Replace Wastewater Plant South Rim Village
GRCA-257282

100% Complete Construction Documents
Addendum 1

June 10, 2026

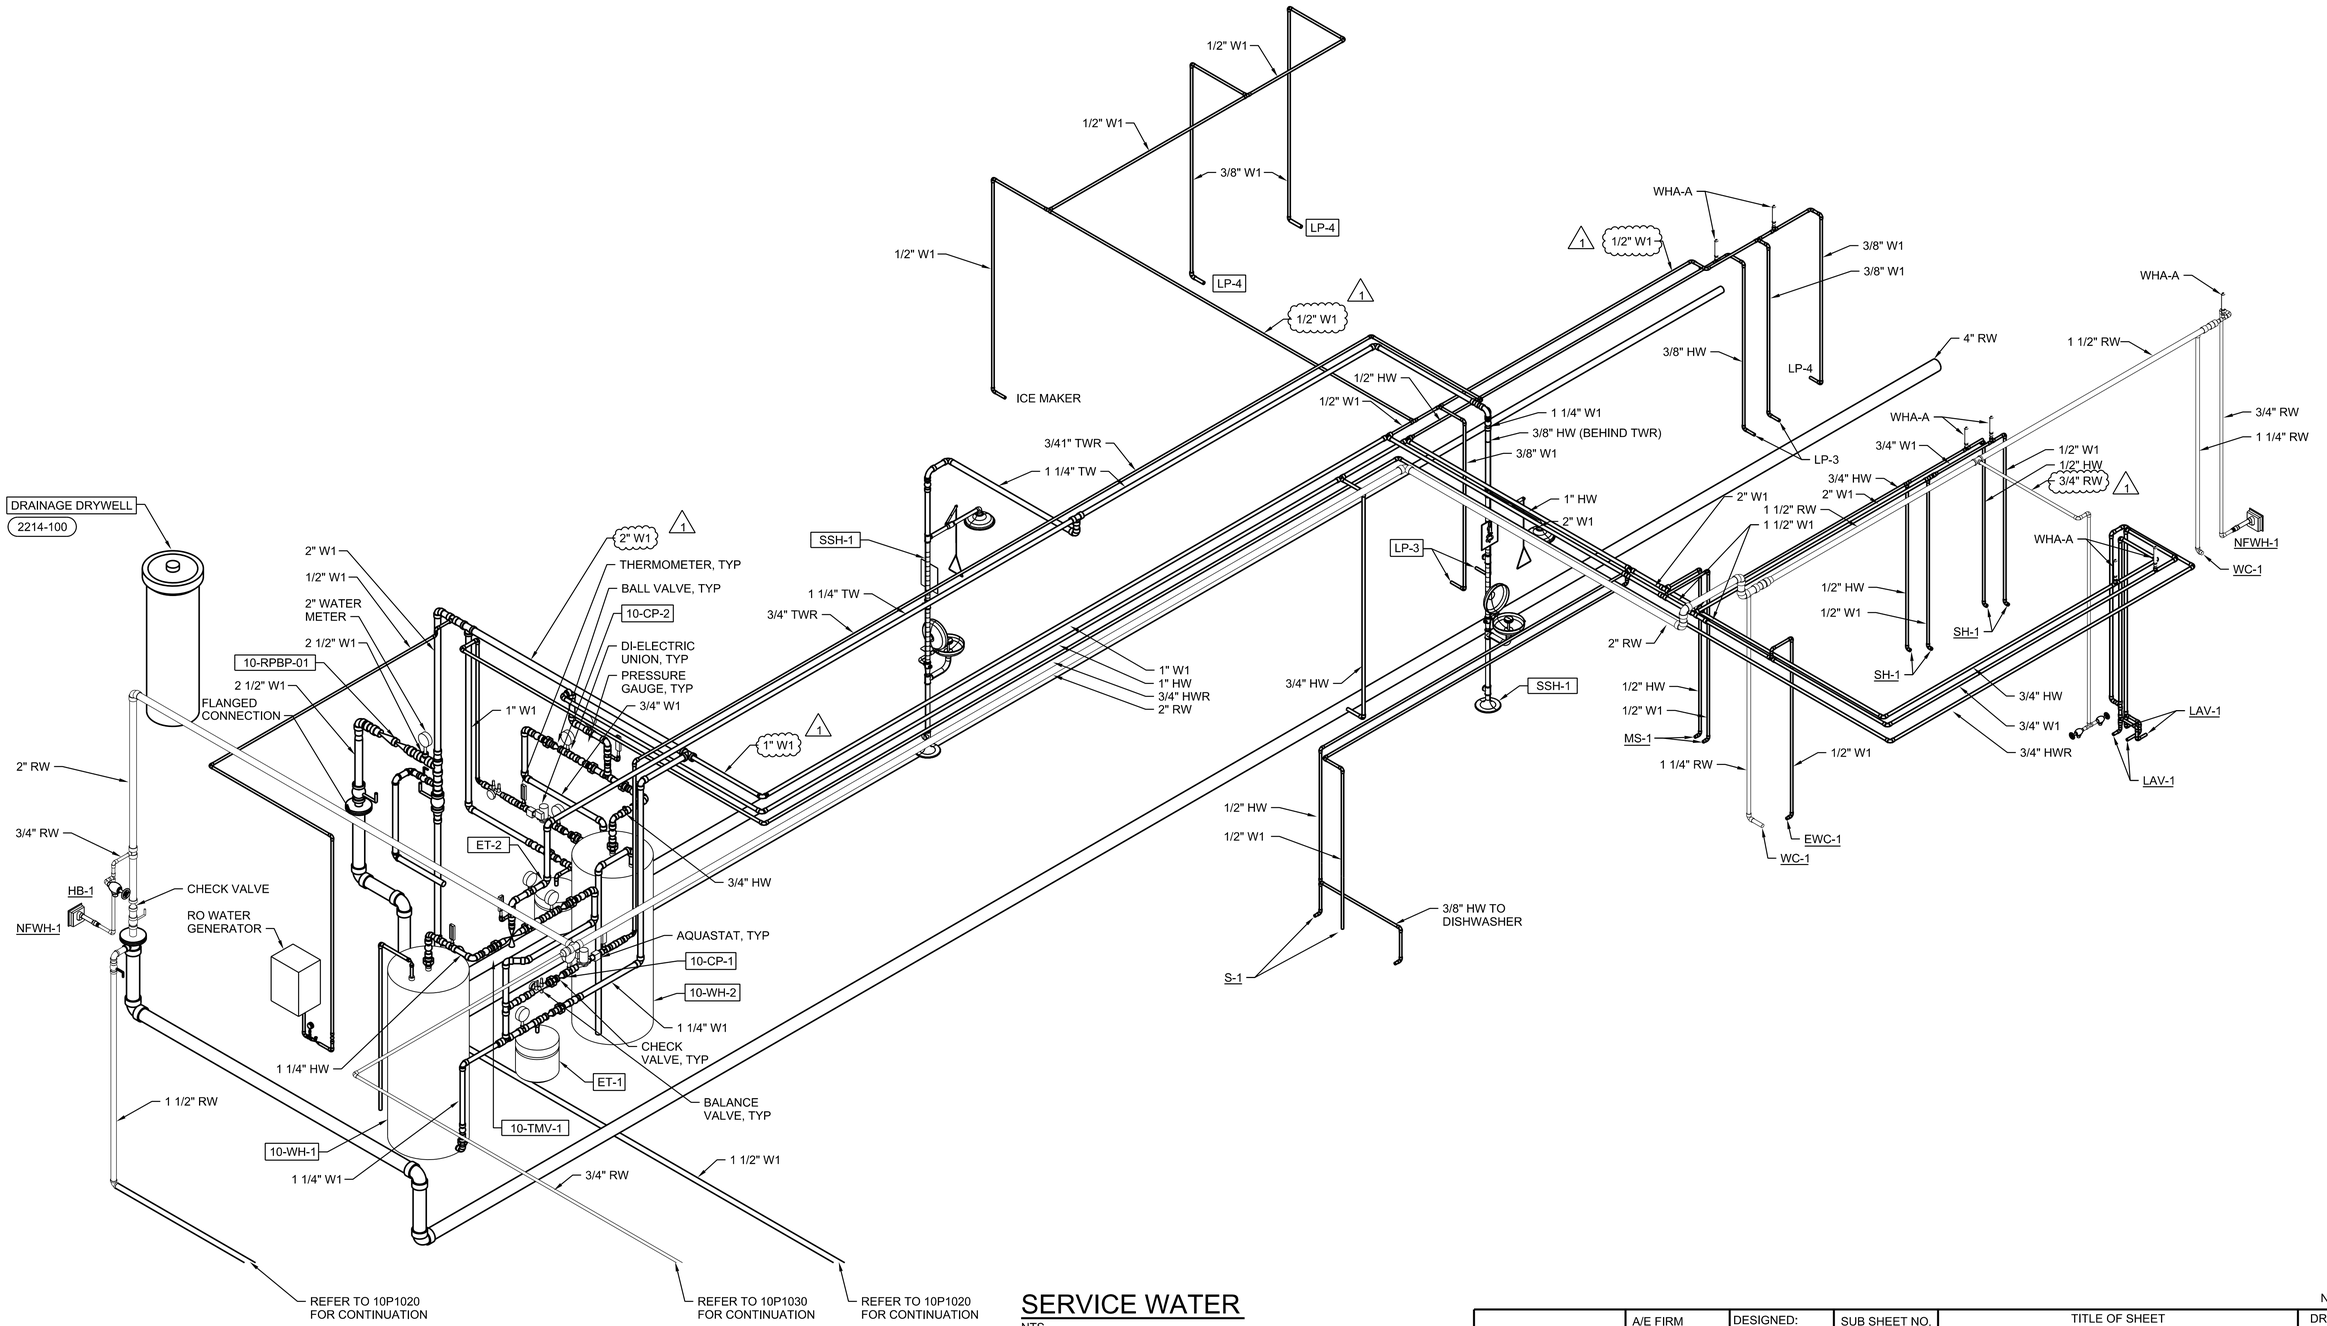
Updated	190A	10A6001	Administration Building Architectural Schedules	Updated Sherwin Williams “Dover Gray” to “Classic French Gray SW0077”
Updated	200A	10P9003	Administration Building Plumbing Isometric	Corrected RW and W1 callouts.
Updated	220A	12A6001	Maintenance Building Architectural Schedules	Updated Sherwin Williams “Dover Gray” to “Classic French Gray SW0077”
Updated	253A	20A6001	Headworks Architectural Schedules	Updated Sherwin Williams “Dover Gray” to “Classic French Gray SW0077”

A/E FIRM	DESIGNED:	SUB SHEET NO.	TITLE OF SHEET	DRAWING NO.
JACOBS GOVERNMENT SERVICES COMPANY GREENWOOD VILLAGE, CO	M CONLAY CADD: G BROWN TECH. REVIEW: D EDWARDS DATE: 08/2025	70D3001	RECLAIMED WATER TANK MECHANICAL SECTIONS GRAND CANYON, SOUTH RIM	113 175376 PMIS/PKG NO. 257282 SHEET 342A OF 49

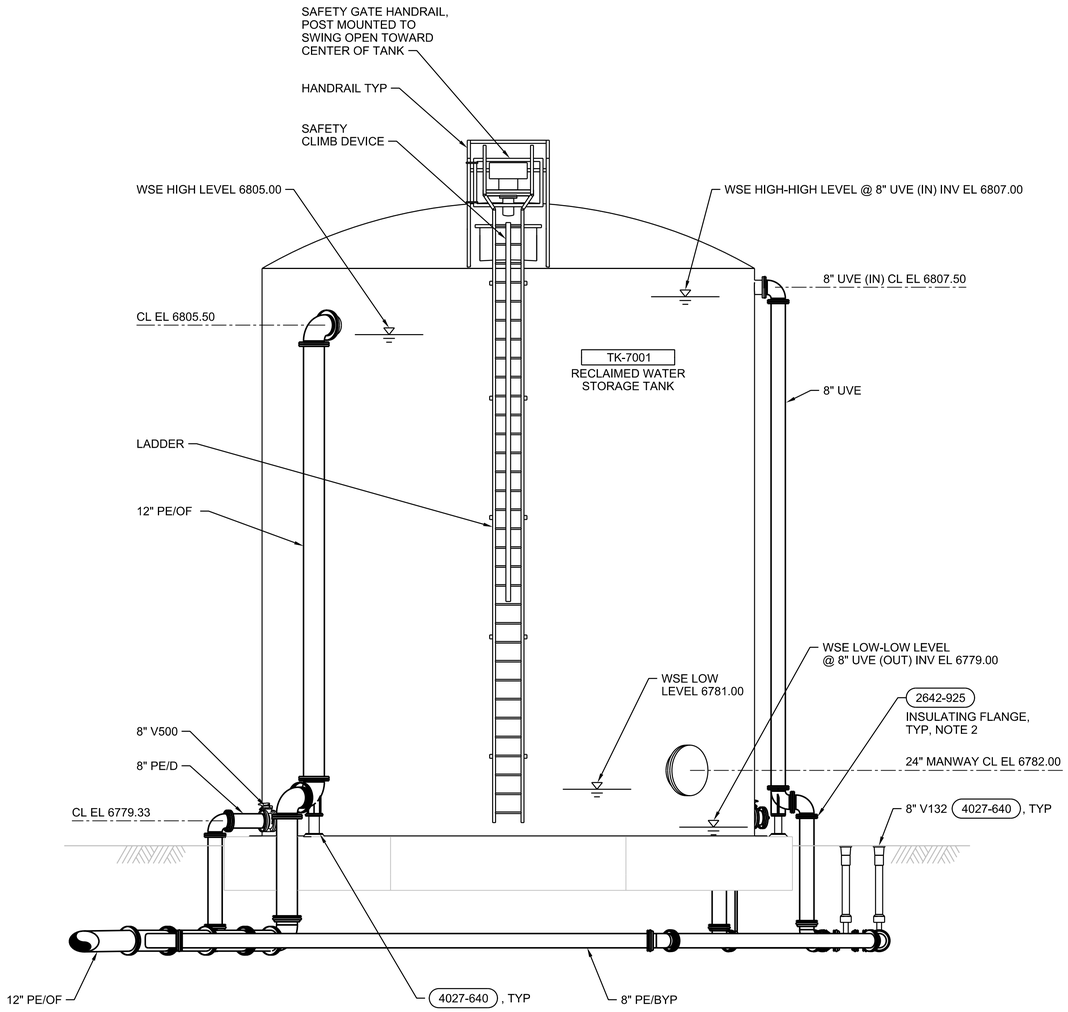
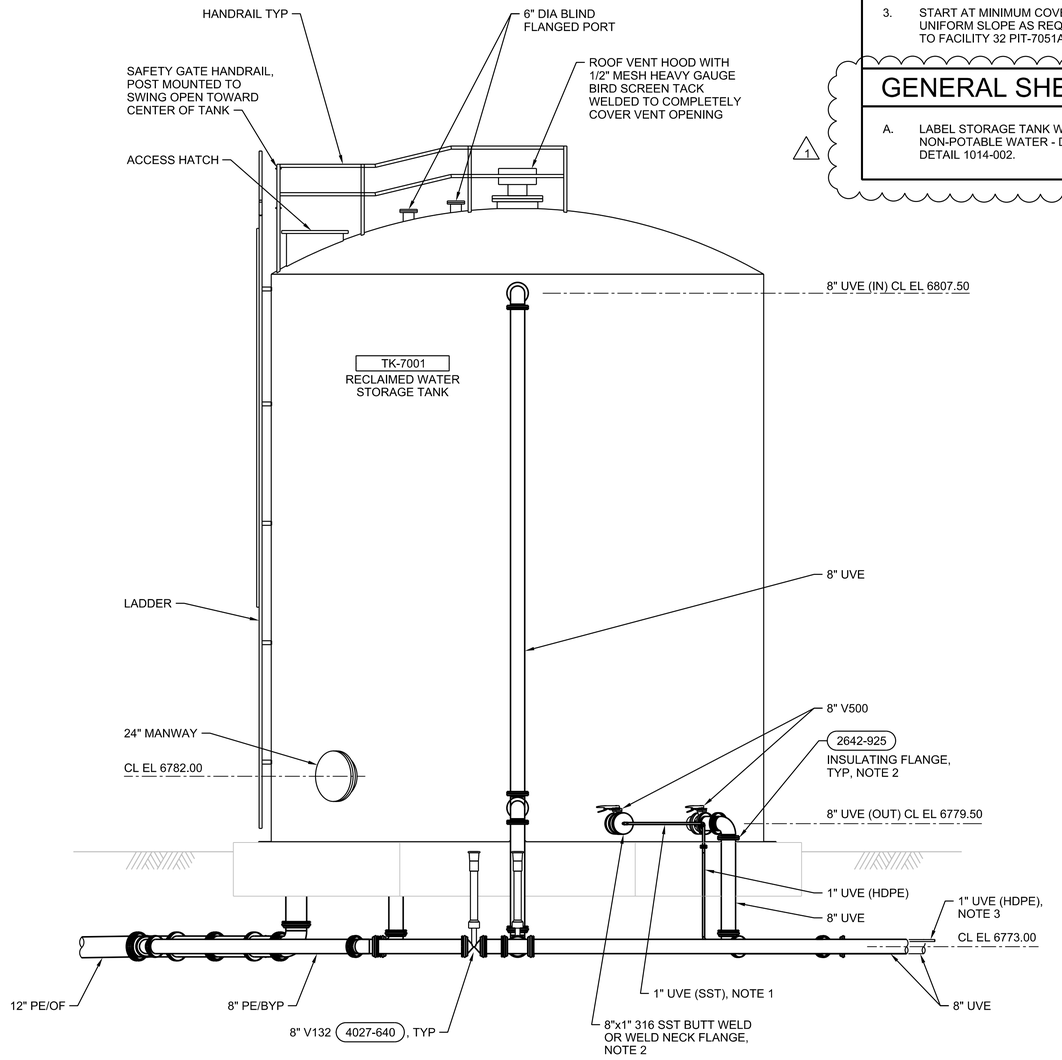
Updated	311A	32A6001	Process Building Architectural Schedules	Updated Sherwin Williams "Dover Gray" to "Classic French Gray SW0077"
Updated	342A	70D3001	Reclaimed Water Tank Mechanical Sections	Addition of non-potable water signage
Updated	357A	80A6001	Digester Facility Architectural Schedules	Updated Sherwin Williams "Dover Gray" to "Classic French Gray SW0077"

A. LABEL STORAGE TANK WATER "CAUTION! NON-POTABLE WATER - DO NOT DRINK" REFER TO DETAIL 1014-002.

CAUTION SIGN

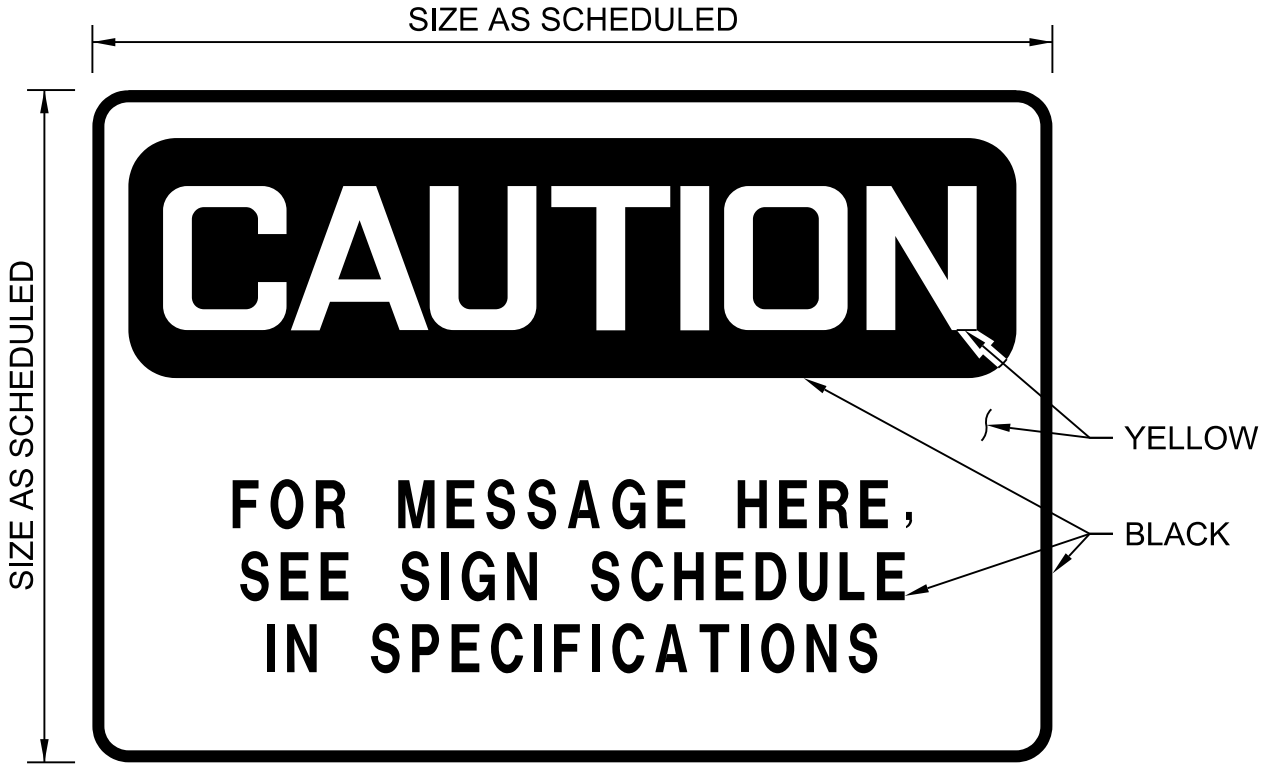
New of Updated	Standard Detail No.	Name	Description
Updated	Index	Index	Added detail 1014-002
Updated	1014-002 Detail 1 of 2	Caution Sign	Made Detail 1 of 2
New	1014-002 Detail 2 of 2	Caution Sign	Detail 2 of 2; New detail for non-potable water utilization
Updated	2240-100A	Hub Drain	Deleted reference to trap primers

DETAIL 2 OF 2

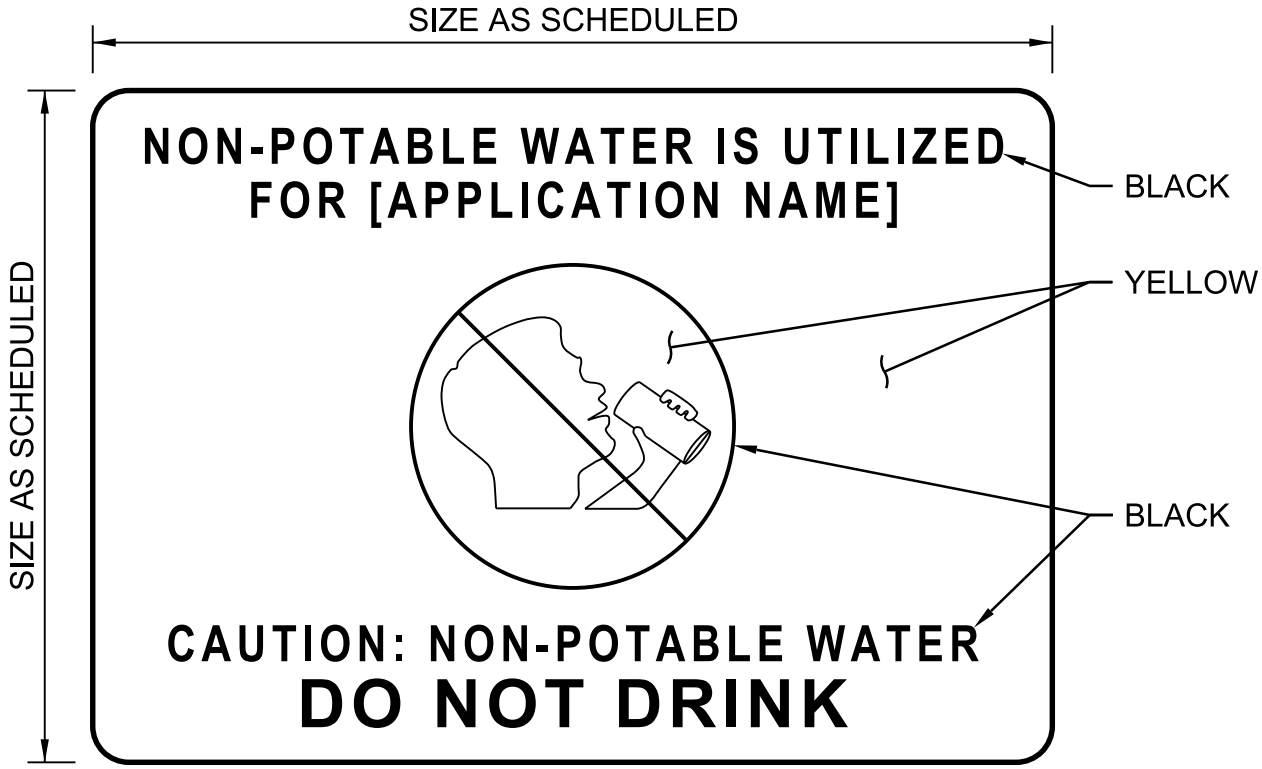
1. USE FOR SIGNS S-8 AND S-9 IN SIGN SCHEDULE OF SPECIFICATION SECTION 10 14 00 SIGNAGE.
2. TEXT TO BE 1/2" MINIMUM IN HEIGHT.
